**CLEARVIEW PUD
MULTI-FAMILY
FINAL SITE DEVELOPMENT PLAN
FILING No. 5
(*Continued Public Hearing)**

SUBJECT: *Continued Public Hearing - Clearview PUD, Multi Family Final Site Development Plan Filing No. 5

AGENDA ITEM DESCRIPTION: The applicant, Clearview Holdings, LLC, c/o Journey Homes, LLC, has submitted a request for approval of a final site development plan for land located in the north central part of the Clearview PUD.

**REVISED
ELEVATIONS**

A3.1

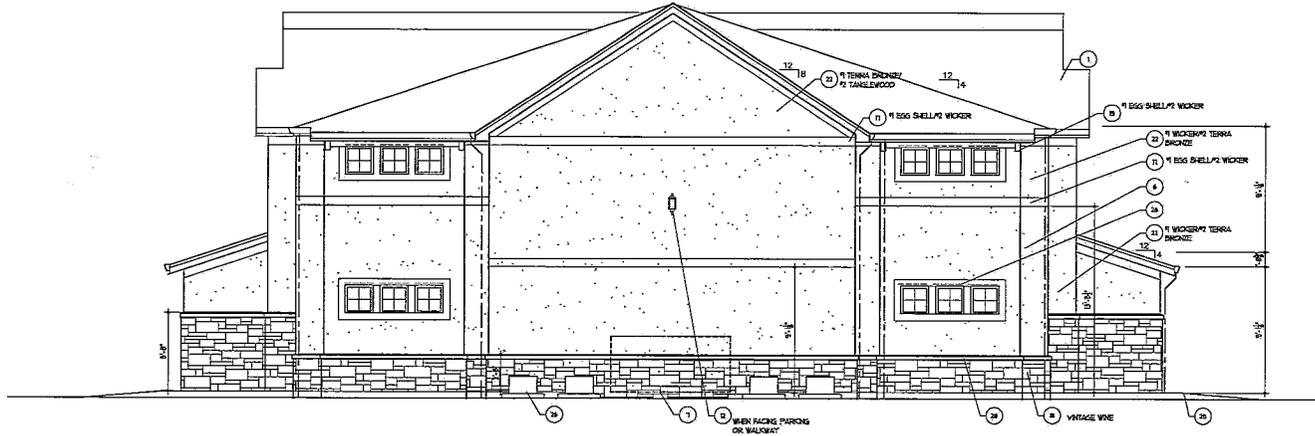
Journey Homes has submitted a proposal for removing the siding from the buildings and replacing the siding with stucco. This is acceptable to town staff.

- (1) As to architecture, Town staff would like the siding removed and replaced with stucco. The current amount of non-stucco masonry is sufficient. If the developer would like to add more non-stucco masonry along with the addition of stucco and removal of the siding, Town staff would not be opposed, but would like to see the drawings before it offers firm approval of that design. You can rely on this written statement. If there is any question or ambiguity about the intent, please let me know.

Please see attached designs of both the 6-plex and 8-plex floor plans. All siding has been removed, and stucco has been added in its place as per Staff's request and direction. In regards to the non-potable system, an agreement is in the works with the HOA's, and I am very happy with the progress we have made. As always, I can be reached at the office.
